FARM 12 - PARKING LOT REVISION

CIVIL SITE PERMIT

1st Review
PRCCP:20241731
Dec 2024

Cecil & Associates comment response
Date: 8/19/2025
By: Roger Cecil

C-01

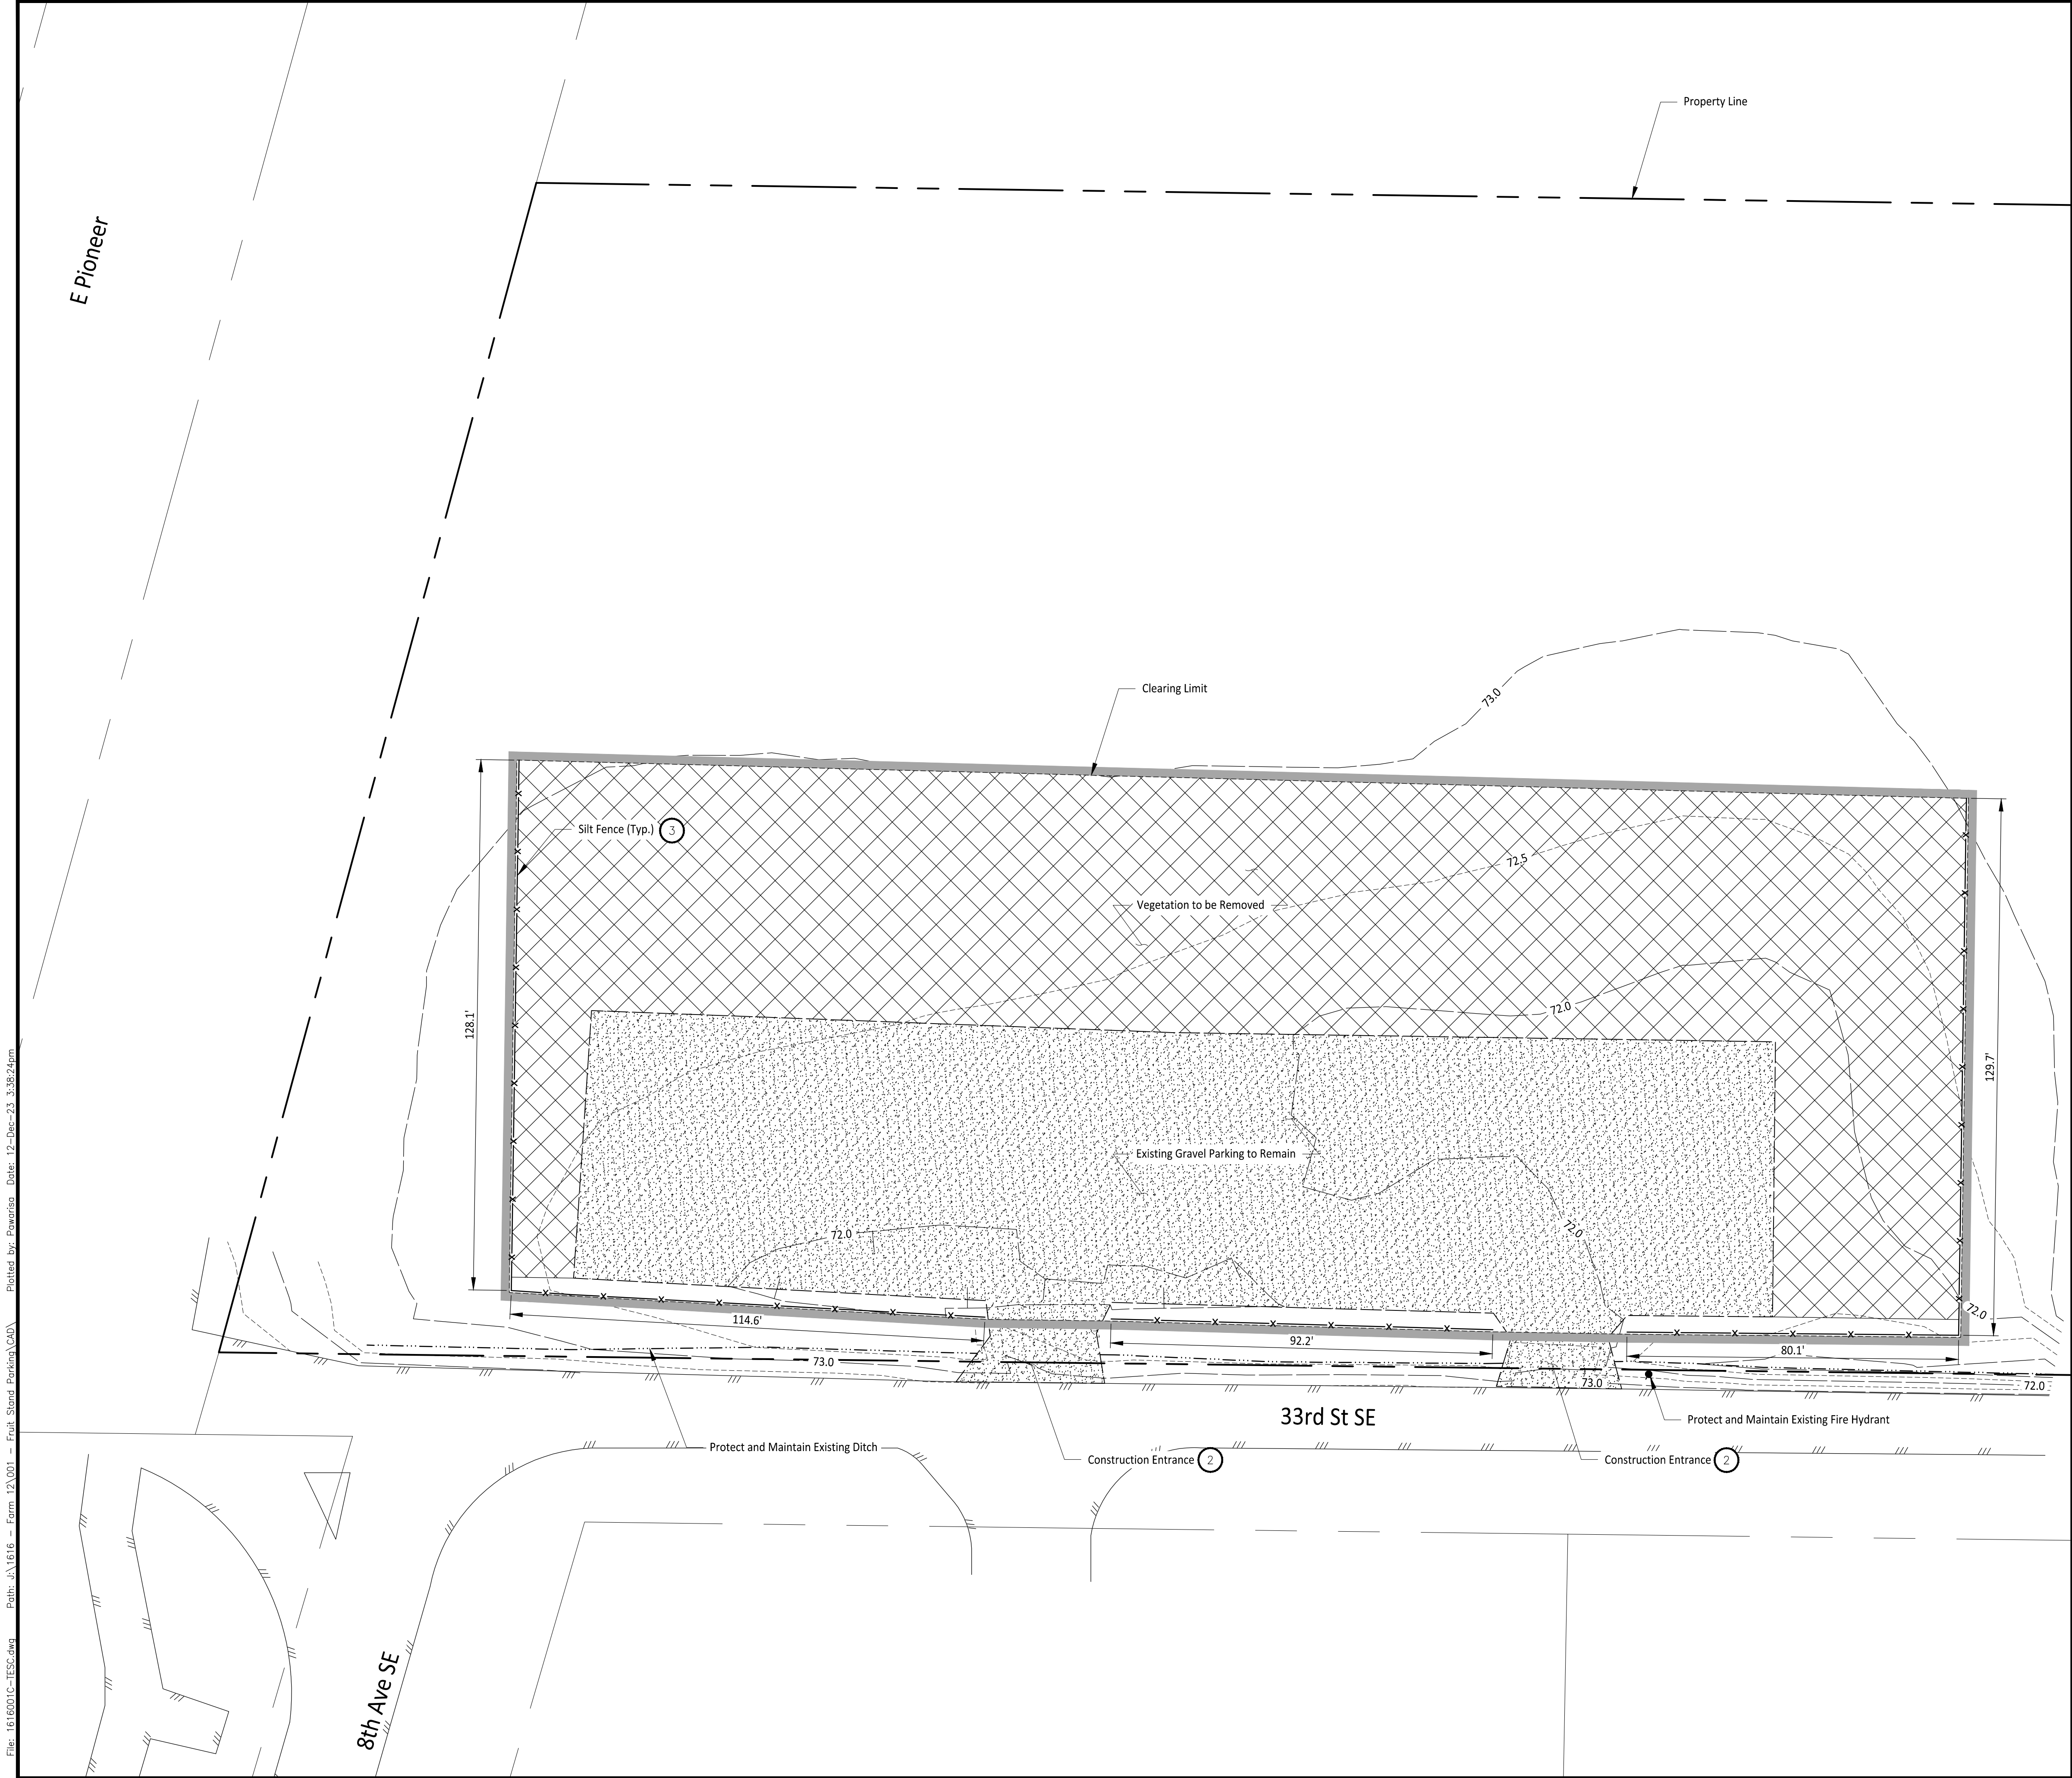
Provide a brief Construction Sequence per City Standards Section 501.6. [Plans: Sheet C-01 of 7]

Callout and show the Williams Gas Easement on the project plan views. (Typ.) [Plans: Sheet C-01 of 7]

Provide Pierce County approval acknowledging the project's connection to the direct discharge conveyance system and ultimately the outfall in accordance with the County issued Shoreline Substantial Development permit. (Ref. MHigginson email to JMJ dated 12/17/24). [Plans: Sheet C-01 of 7]

A construction sequence has been added to Sheet C2.00 TESC Plan.

Williams Gas Easement has been added to all plan views.

Please refer to M. Higginson email dated 8/11/2025. Mr. Higginson agreed that Pierce County approval would be required when the storm extension (condition of ELC project) is constructed, because that constitutes a connection to the Viking Line.

C-05

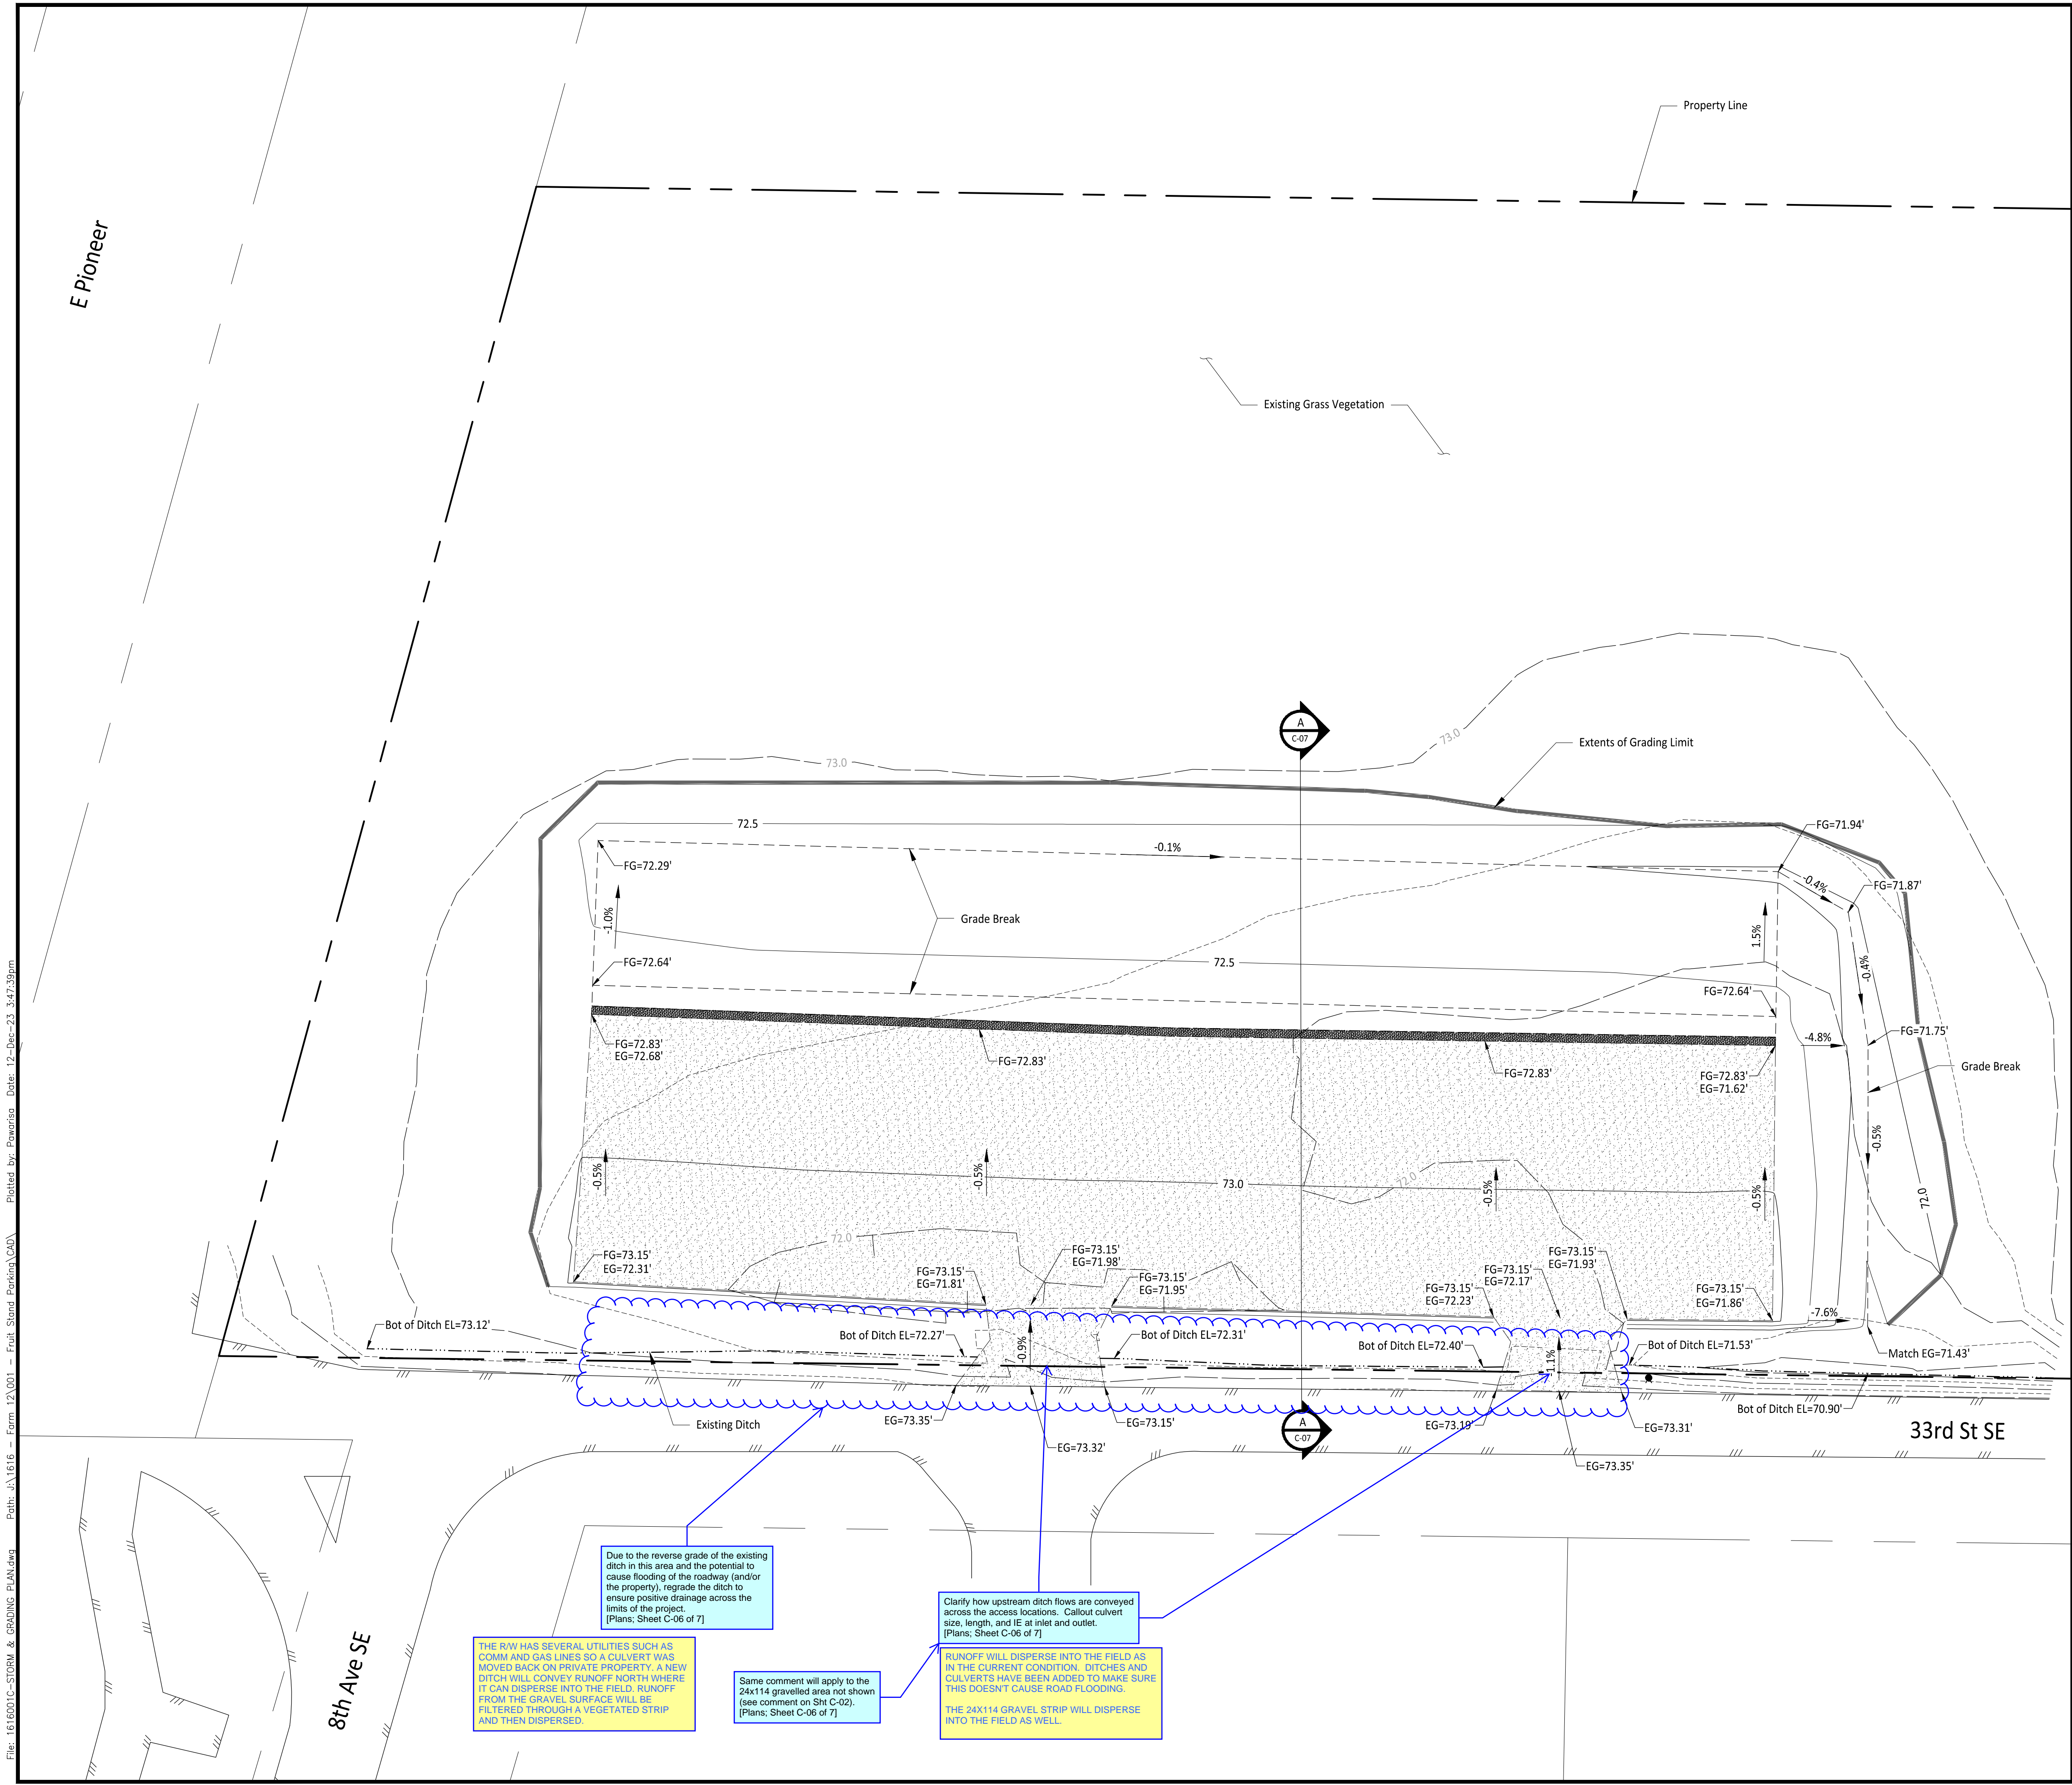
Please add note: "See City Standard Detail 01.02.08a." (Plans, Sheet C-05 of 7)

THE REFERENCE TO THE CITY STANDARD DETAIL HAS BEEN ADDED TO CROSS SECTIONS ON SHEET C4.10. DETAILS HAVE BEEN ADDED TO C4.11.
